# UNITED STATES PATENT AND TRADEMARK OFFICE

| APPLICATION NO.  | FILING DATE | FIRST NAMED INVENTOR | ATTORNEY DOCKET NO. | CONFIRMATION NO. |
|--|-------------|----------------------|---------------------|------------------|
| 10/072,707   | 02/05/2002  | Alain Houle          | CISCP730            | 1909             |

| <b>Office Action Summary</b> | Application No.<br>10/072,707 | Applicant(s)<br>HOULE ET AL. |  |

## DETAILED ACTION

Fig. 4A

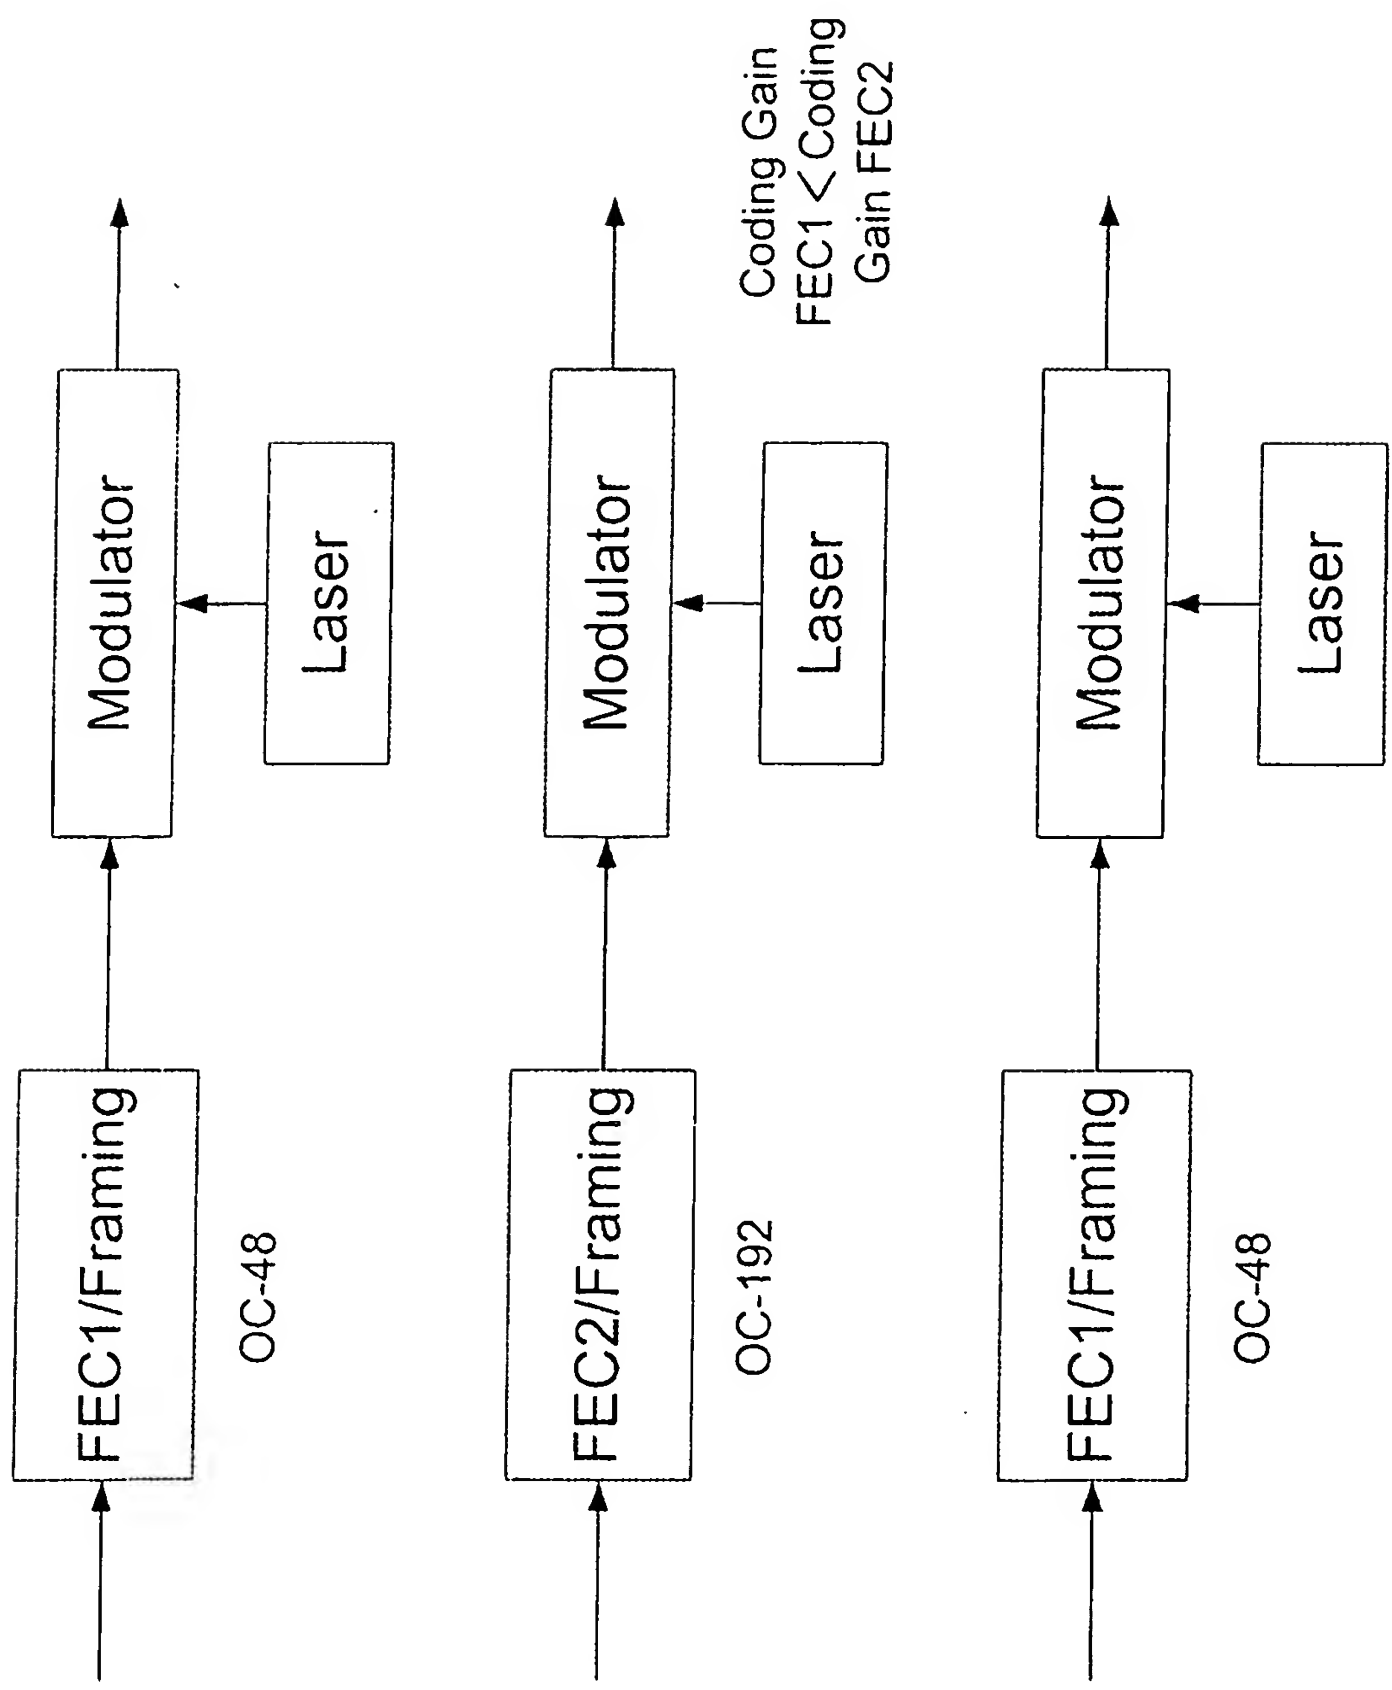
1. Applicant's compliance with the objections to the drawings in the previous Office Action (mailed on 28 April 2006) is noted and appreciated. Applicant presents arguments to assert that Fig. 4A is supported in the Applicant's specification, citing portions from p. 8-9 of the specification (arguments filed on 28 April 2006, p. 10+). In particular, citation of the following portion is persuasive:

“Alternatively, error correction coding techniques may also be employed on both the higher data rate and lower data rate signals with different coding gain” (Applicant's specification, p. 9, l. 20-22).

In the context of the specification, “the higher data rate signal” corresponds to an OC-192 signal, and “the lower data rate signal” corresponds to an OC-48 signal. Accordingly, the drawing replacement sheet of Fig. 4A, filed on 24 March 2005, is approved.
